8-E-21-HZ
APPLICATION FOR CERTIFICATE OF APPROPRIATENESS

705 Deery St. 37902
Fourth and Gill H

Original Print Date: 8/9/2021
 Knoxville/Knox County Planning -- Historic Zoning Commission

Level III Construction of New Primary Building

FRONT ELEVATION

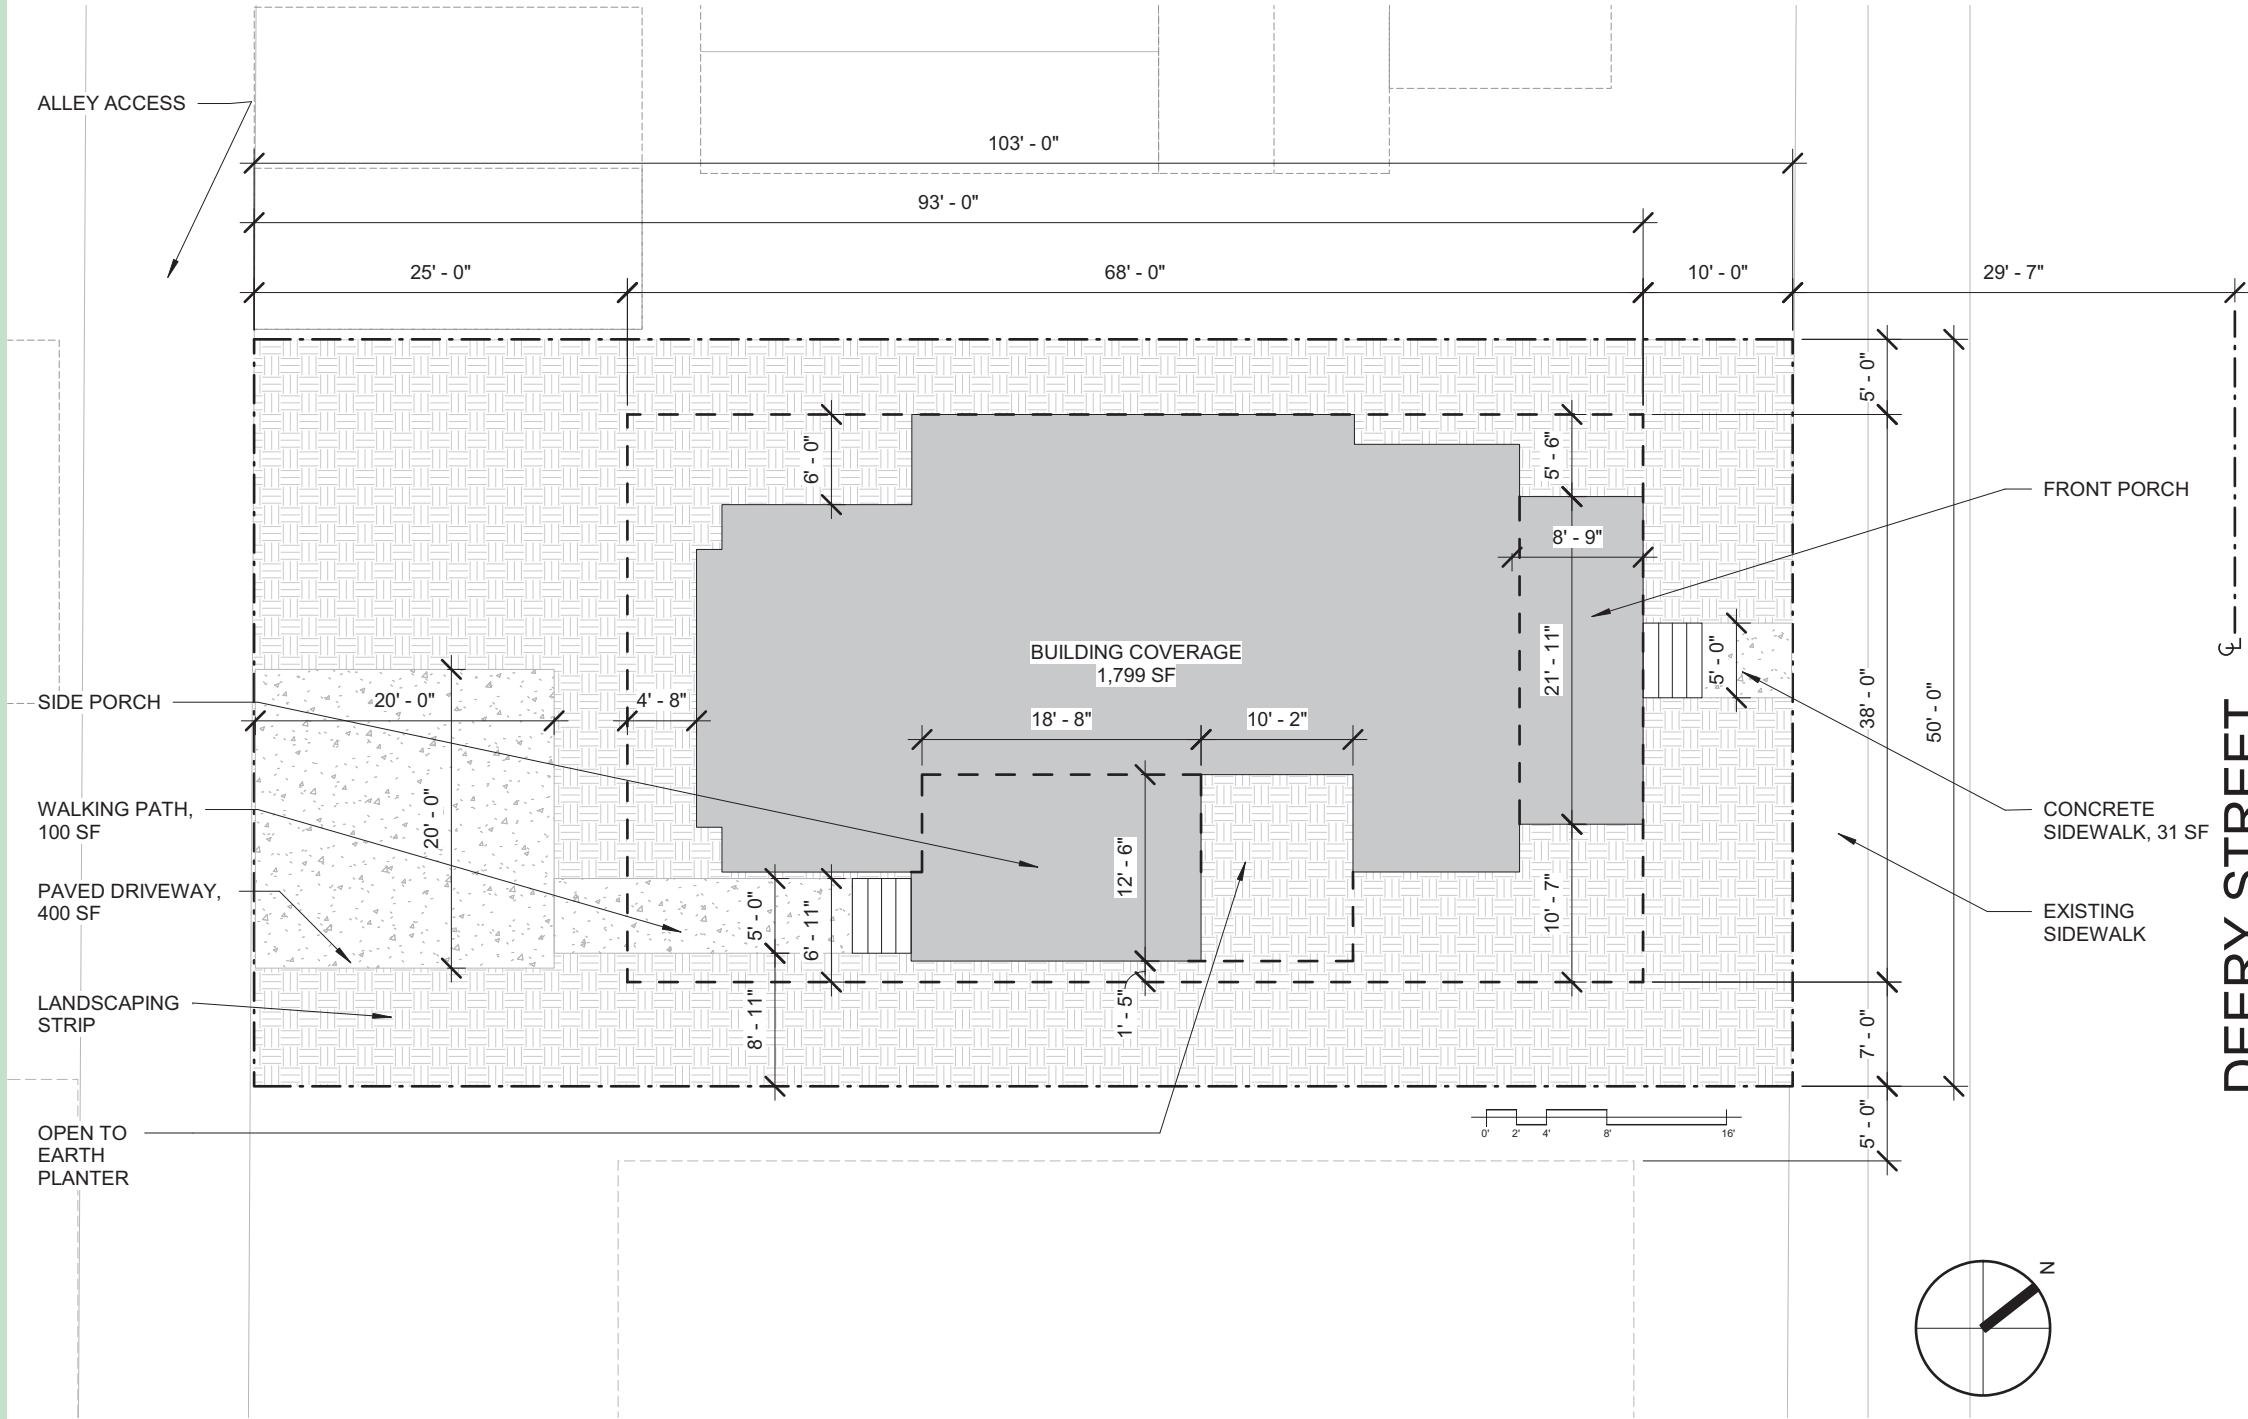
7. The façade integrates a mix of vertical and horizontal elements with horizontal trim bands, brick porch columns, and symmetrical window placement. These elements are characteristic of the Prairie style. The previously-proposed brick pilasters have been removed, in favor of vertical and horizontal trim elements.

11. Using a centrally-located half-light door, flanked by the two square porch columns and accessible via a new concrete walkway from the sidewalk, the design successfully incorporates a strong sense of entry on the front façade.

13. The design includes an 8'-9" deep, 21'-11" wide front porch which is proportionate to the design of the house and historic porches in the neighborhood. The proposed square brick columns and solid wood porch railing/enclosures are consistent with the contemporary interpretation of the Prairie style. The revised front porch is larger than the initial proposal.

Pending the approval of overall massing, size, and scale, staff also recommends the additional conditions of approval: 1) final door selection to be wood and submitted to staff for approval; 2) the use of wood lap siding over HardiePlank siding; 3) using dark-colored asphalt roofing shingles and unpainted brick masonry elements to better connect with the historic context; 4) revision of side elevation windows to create more even proportions on each side.

SOUTH EAST (FOURTH AVE) ELEVATION

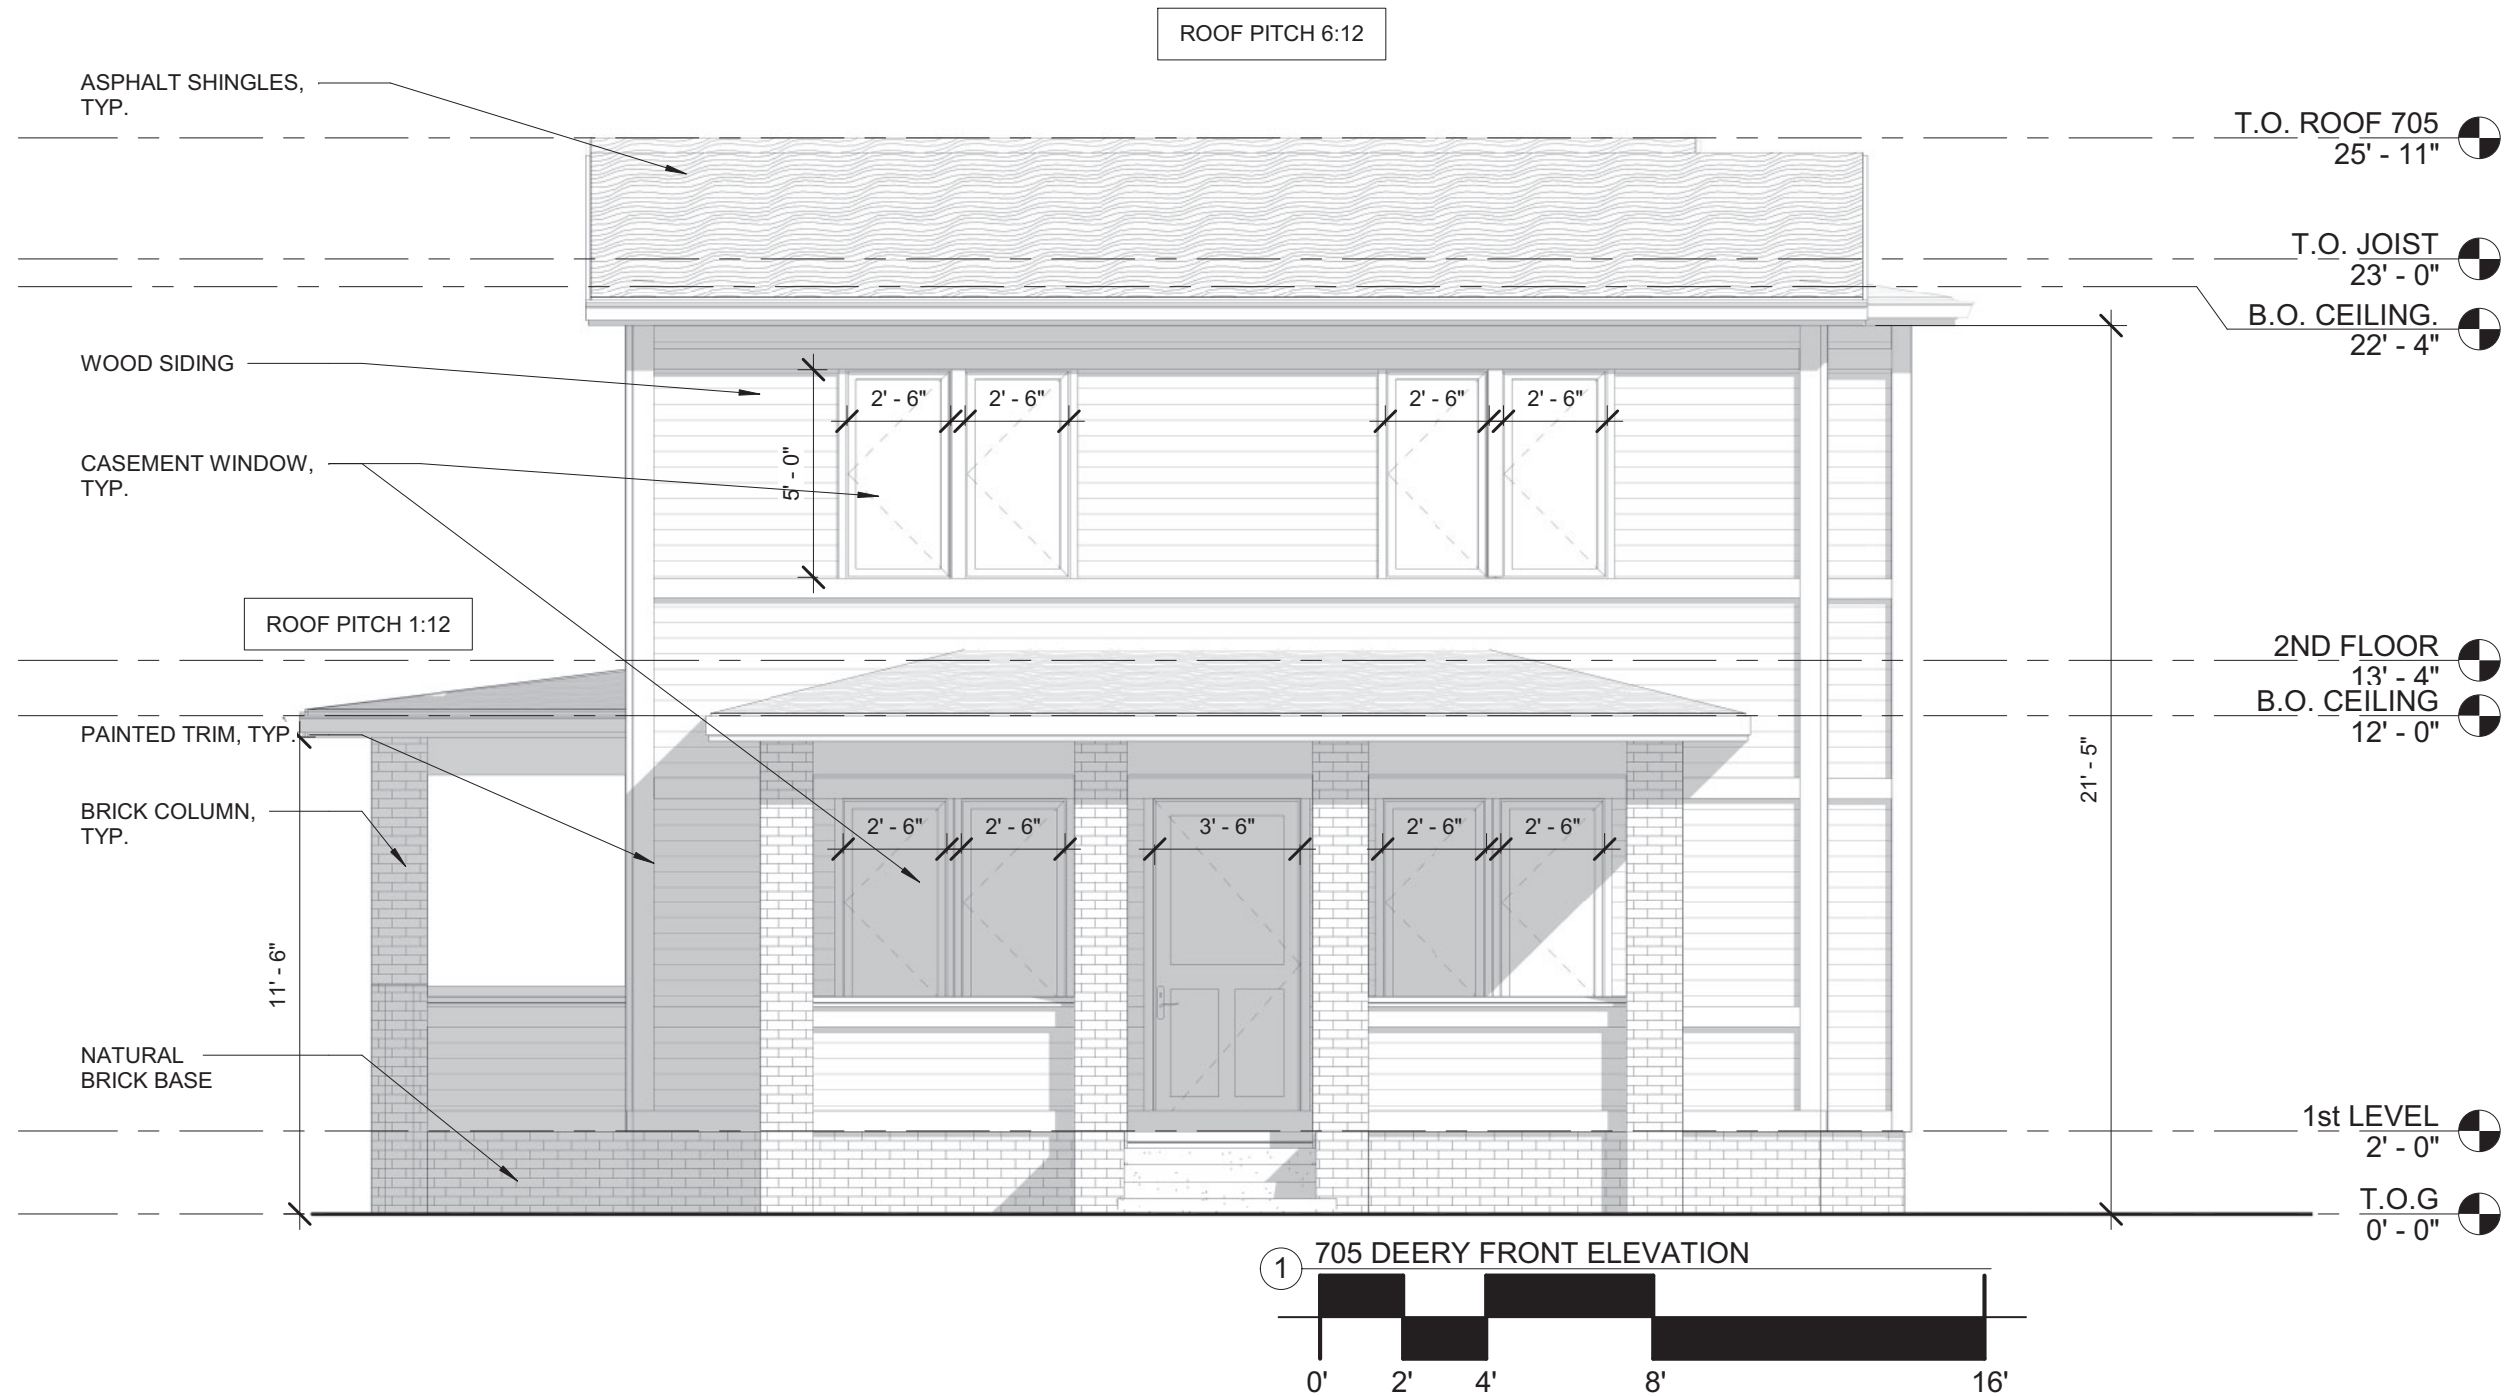
5. To break up the large rectangular form, the proposed house uses varied massings, including the two front-gable massings on the left (southeast) elevation, two one-story, hipped-roof porches, and a variety of siding details. The side elevations are significantly asymmetrical.

NORTH WEST SIDE ELEVATION

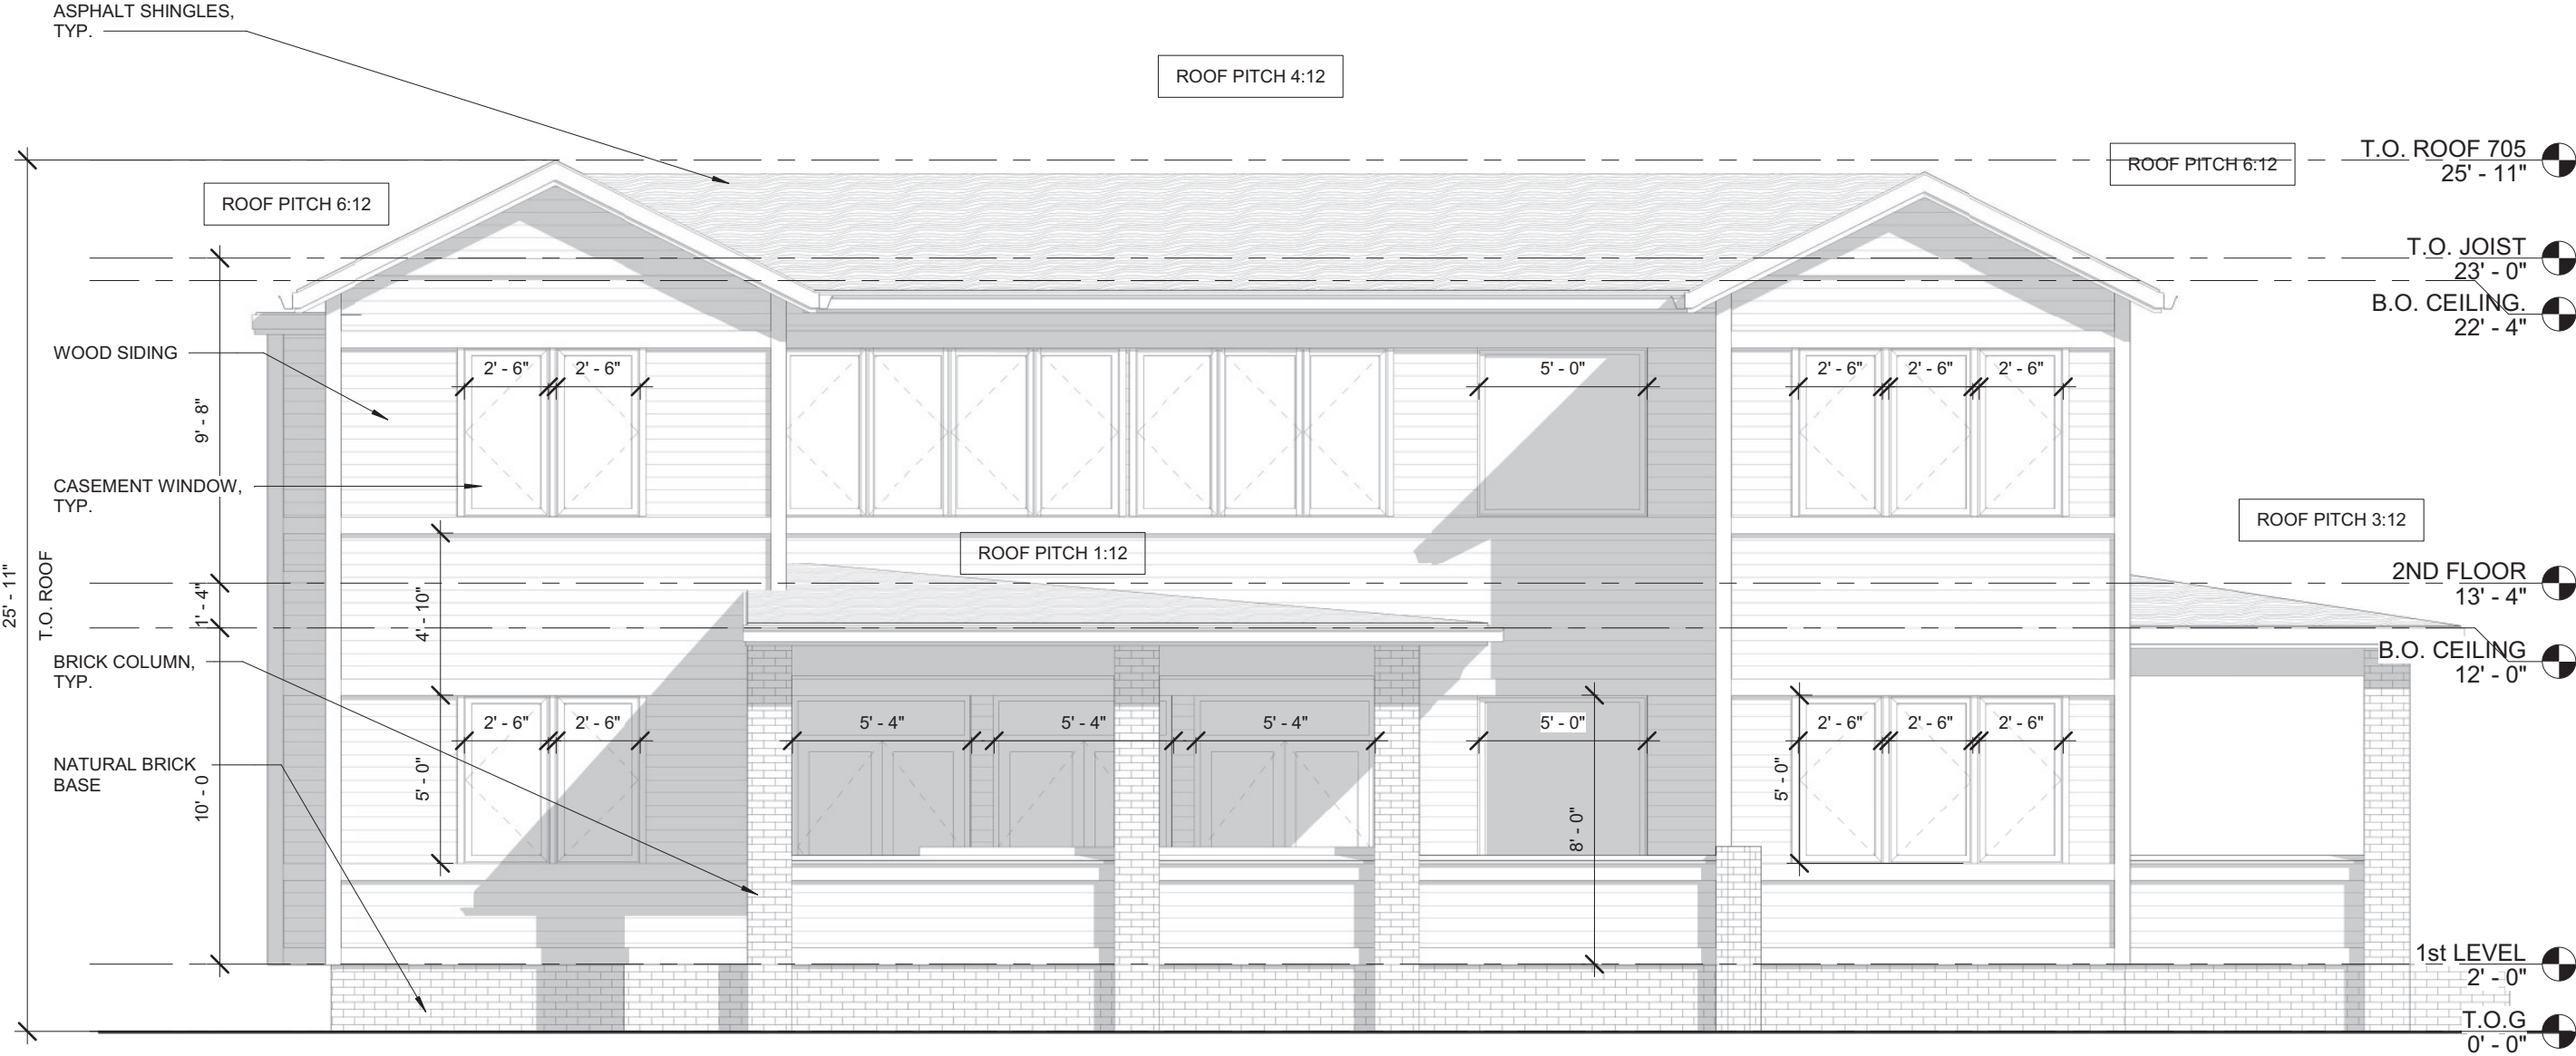
19. The northwest (right) side elevation lacks sufficient transparency, especially towards the rear. With the removal of the brick pilasters, a large swath of solid siding with no transparency is present towards the rear. Modifying both side elevation windows to even out the proportions would assist in "creating a mix of wall areas with [...] window elements like those found on the neighborhood's historic houses."
